Administrative Change Approval Form Order

East Port Water Reclamation Facility Expansion

CCU Change Order Request
East Port WRF Expansion - Poole and Kent
Change Order #5

Change Order No. 5
Original Contingency: \$5,309,430.00
Previous Contingency Changes: \$424,489.64
New Contingency Balance: \$4,750,128.66
Original Contract Time: 900 Calendar Days
Additional Time: 0 Calendar Days
Previous Changes: 173 Calendar Days
New Contract Time: 1073 Calendar Days

RFI TITLE: NEW IR Pump Pad Drain
Dwg Reference: M32
Spec. Reference: _____

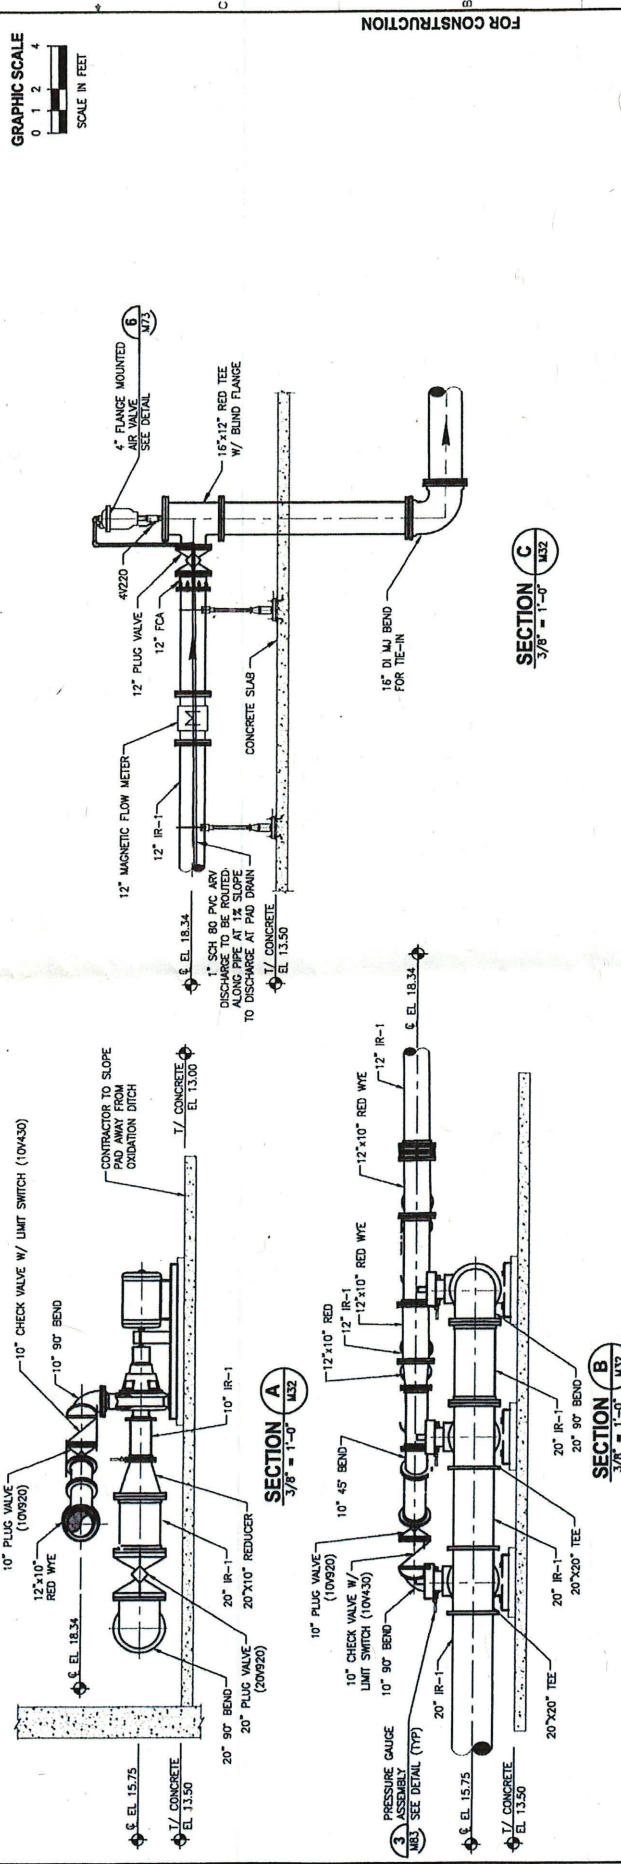
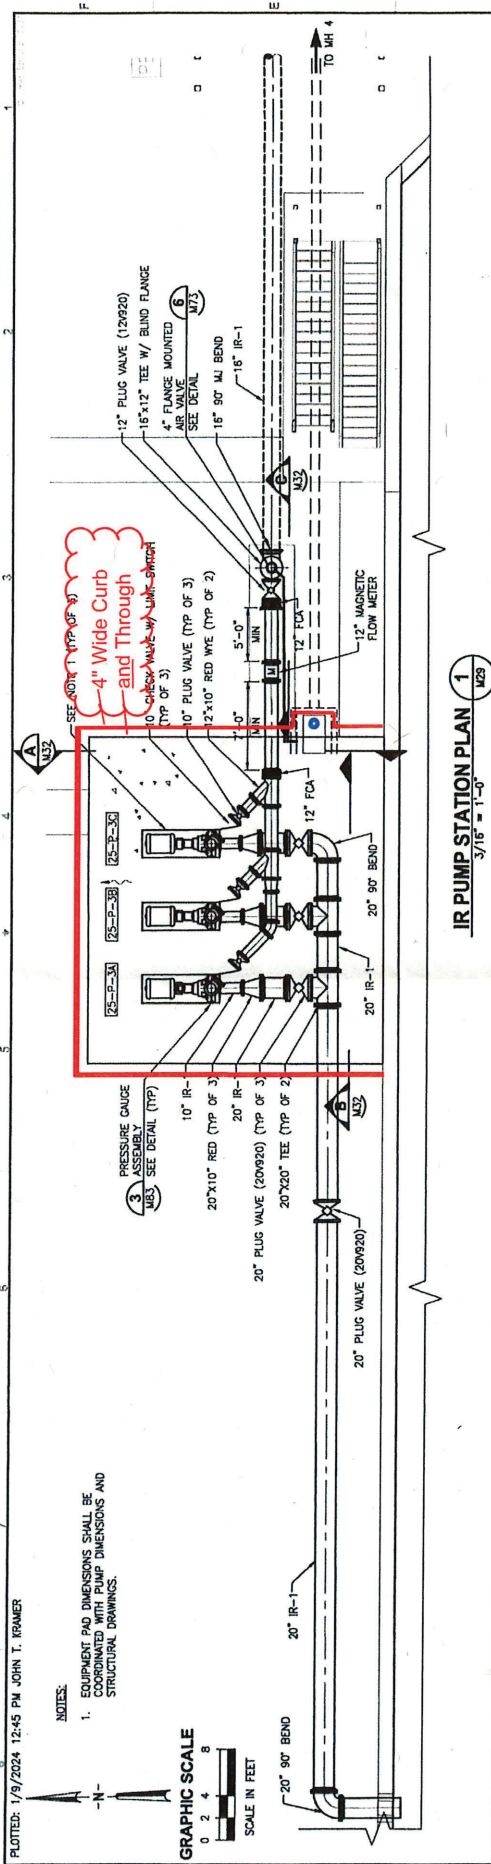
Please see the attached RFI regarding the IR Pump Pad drain. This is shown only on the mechanical drawings with no detail on what is intended to be installed or used as the drain, please review and advise.

Please clarify the design intent on the IR Pump Pad Drain. This Drain is only shown on the overview Mechanical drawings. There is not details or structural drawings for this. Please provide further details and layout on what is intended to be installed or made for the IR Pump Pad Drain.

is Described Below or in the Attached: Please install per attached markup - PDF pages 2 & 3.
PCM to follow.

Revised Drainage Configuration

REASON FOR MODIFICATION: To accommodate wash down procedures.
